APPLICATION NO.	FILING DATE	FIRST NAMED INVENTOR	ATTORNEY DOCKET NO.	CONFIRMATION NO.
10/600,698	06/23/2003	Masakazu Okuda	053588-5012	5737
9629	7590	01/21/2005	EXAMINER	
MORGAN LEWIS & BOCKIUS LLP 1111 PENNSYLVANIA AVENUE NW WASHINGTON, DC 20004			MOUTTET, BLAISE L	
			ART UNIT	PAPER NUMBER
			2853

Office Action Summary	Application No. 10/600,698	Applicant(s) OKUDA ET AL.	
	Examiner Blaise L Mouttet	Art Unit 2853

DETAILED ACTION

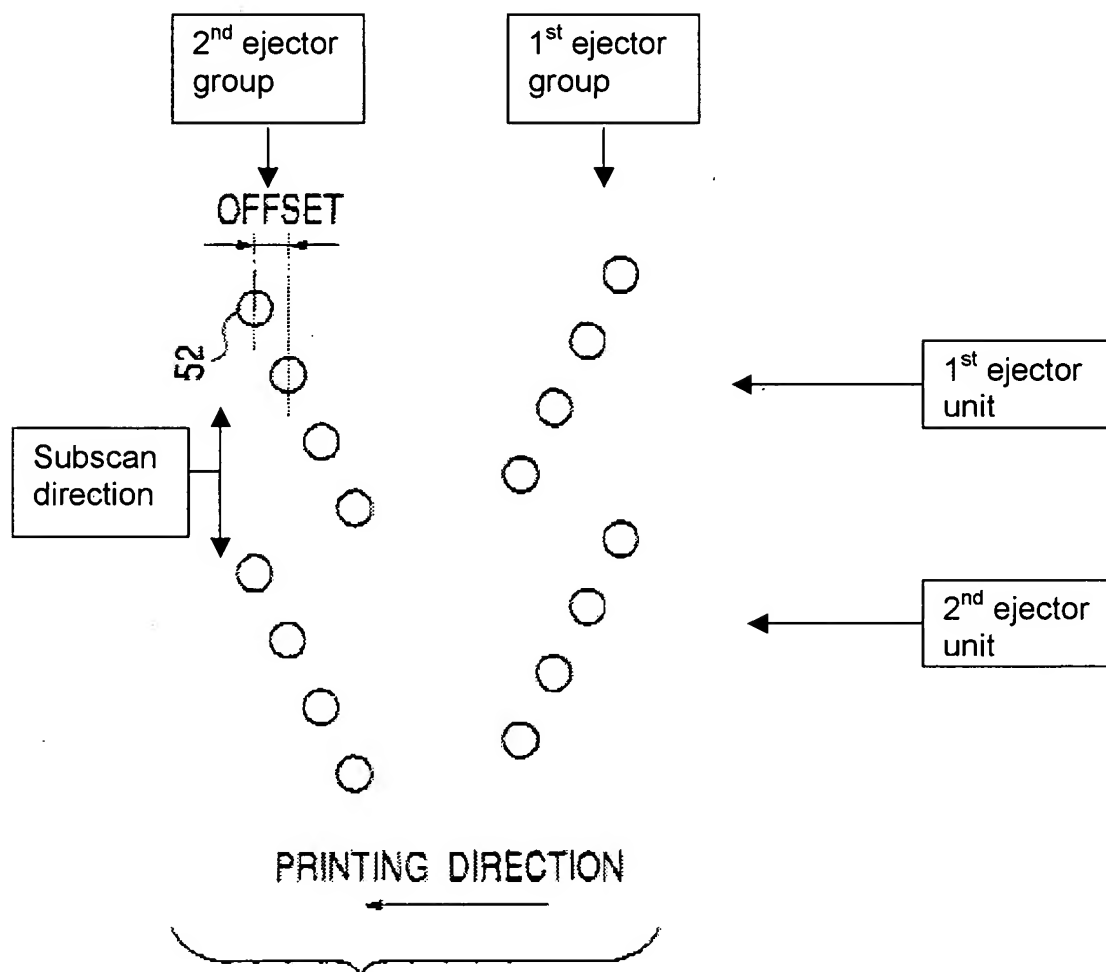
the liquid drop discharging head (figures 1A-1C) comprising ejector units arranged along the main scanning direction (printing direction of figures 1A and 1B), wherein:

each ejector unit includes a first ejector group (shown on the following page) arranged at one side in the main scanning direction and a second ejector group (shown on the following page) arranged at another side in the main scanning direction;

all of the ejectors are arranged two dimensionally in a predetermined plane (figure 1B);

all of the nozzles are offset from each other in a sub-scanning direction which is perpendicular to the main scan direction (as evident from figures 1A and 1B); and

the nozzles of each ejector group are alternately arranged so that when they are viewed in the main scanning direction, a nozzle of one ejector of the first ejector group, a nozzle of one ejector of the second ejector group, a nozzle of another ejector of the first ejector group, a nozzle of another ejector of the second ejector group, etc. are arranged in such an order in the sub-scanning direction (as shown in figure 1B nozzles are arranged in the sub-scan direction such that the uppermost nozzle of the 1st group

(right side group) is arranged, followed by the uppermost nozzle of the 2nd group (left side group), followed by the second uppermost nozzle of the 1st group, followed by the second uppermost nozzle the 2nd group, etc.)

FIG. 2

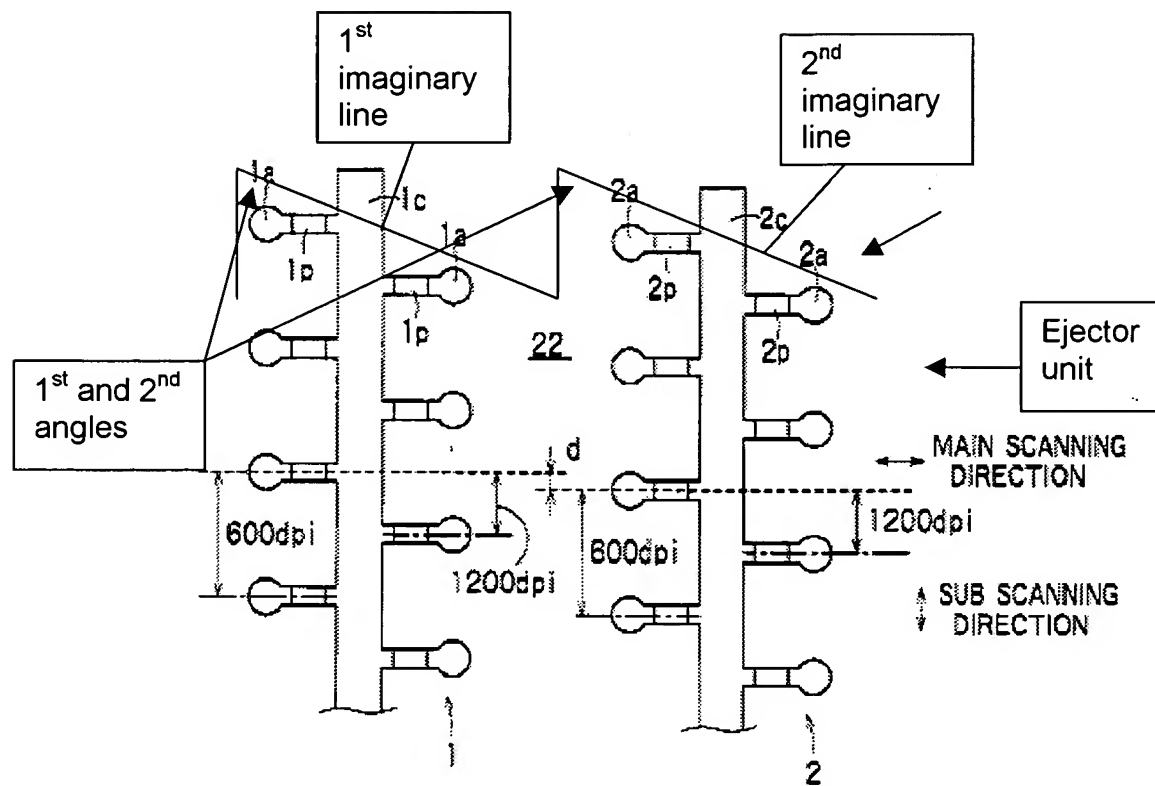
the nozzles of each ejector group are alternately arranged so that when they are viewed in the main scanning direction, a nozzle of one ejector of the first ejector group, a nozzle of one ejector of the second ejector group, and rotates this order in the sub-scanning direction (as shown in figure 2 nozzles are arranged in the sub-scan direction such that the uppermost left nozzle of group 1a is arranged, followed by the uppermost left nozzle of group 2a, followed by the uppermost right nozzle of group 1a, followed by the uppermost right nozzle of group 2a, etc.);

a first imaginary line connecting the ejectors of the first ejector group is inclined at a first angle with respect to the sub-scanning direction (see figure 2 on the following page);

a second imaginary line connecting the ejectors of the second ejector group is inclined at a second angle with respect to the sub-scanning direction (see figure 2 on the following page);

said first and second angle are substantially the same (see figure 2 on the following page).
